RESOLUTION OF THE BOARD OF COUNTY
COMMISSIONERS OF NASSAU COUNTY,
FLORIDA, RELATING TO DREDGE-FILL
PERMIT FOR AMELIA RIVER

RE: Dredge-Fill Permits for Amelia River
Section 74060-2507(2505), Nassau County, Florida

PERMIT APPLICATION APPRAISAL

Purpose of work: Replace bridge

FIG. 1 EAST BANK OF AMELIA R.

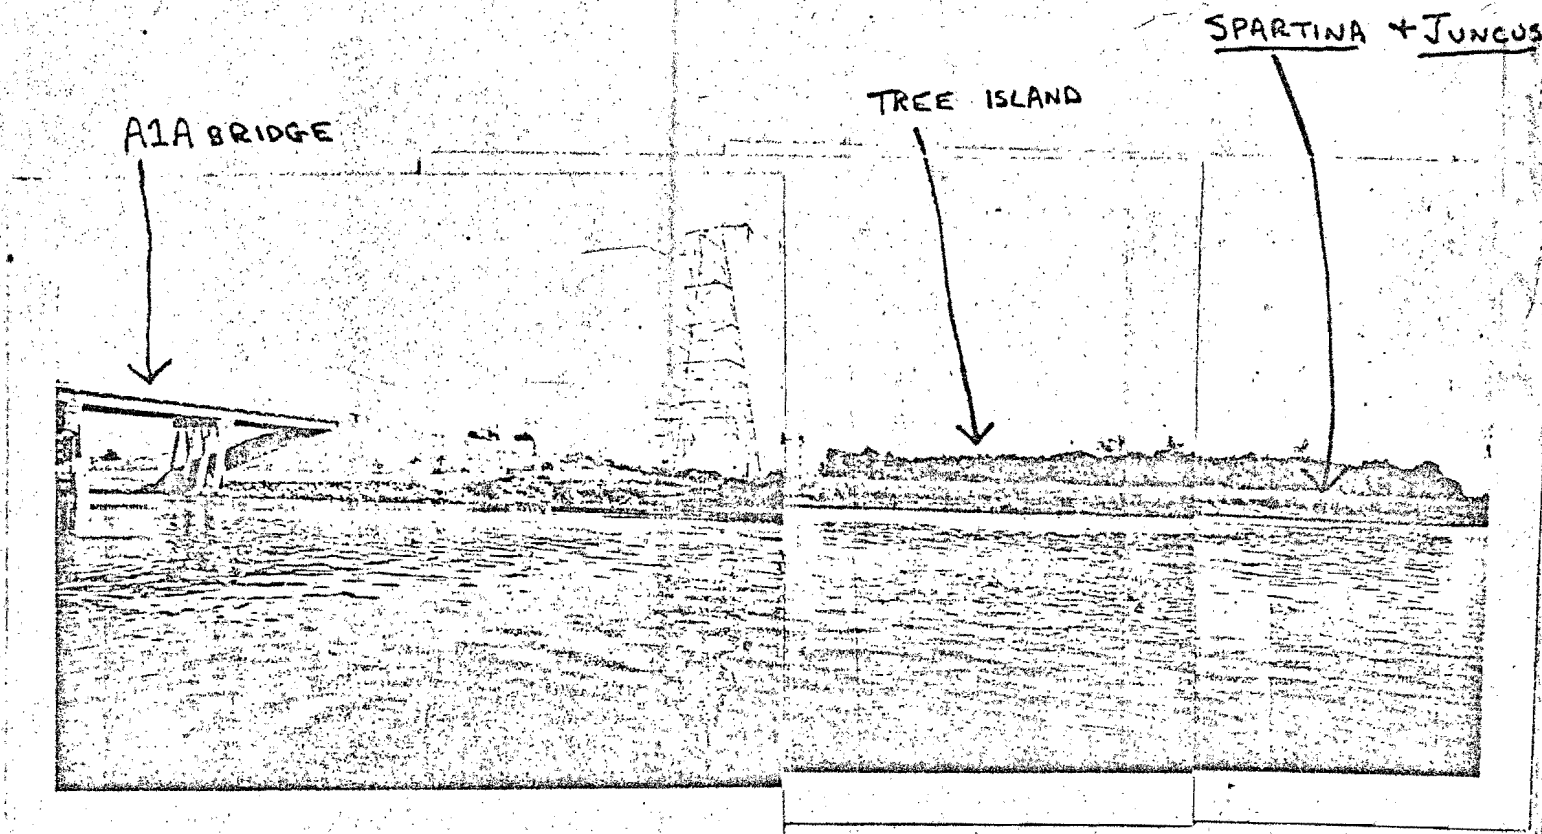
This area is predominantly Juncus marsh, with a fringe of Spartina near the open river water. This portion of the Amelia River system (channel & wetlands) is the narrowest part of the entire river, measuring about 1 1/4 mile wide. There is a commercial marina/boat repair facility on one tributary a bit north of the present bridge. There is also a small fish house just to the north of the bridge, also a railroad bridge parallel to and about 200 ft. north of the preexisting highway bridge. There are no other developments in the area. There were few signs of commercial fishing activities (2 boats, a few crab traps) in this area of the river.

Portions of the work site are the previously filled areas for the present bridge. The rest of the area is a dense Juncus marsh, with portions below the zone of high water vegetated by Spartina. This zone involves only a thin fringe along the river channel, but larger pockets in other areas back from the river. The soil in the vegetated zones is a mixture of sand and mud. As site inspection was made at a period of very low tide, sampling for fauna in the wetlands was not performed.

This project will destroy 1.8 acres of Spartina marsh and about 23 acres of Juncus marsh. This area is between 2 proposed aquatic preserves, but not adjacent to either. Due to the presence of the existing roadbed, there will be no additional modification of flow patterns. The bridge structures will not be in the river, so there should be no long-term adverse impact there. The only long term impact will be the removal of the marshland from the vegetative ecosystem.
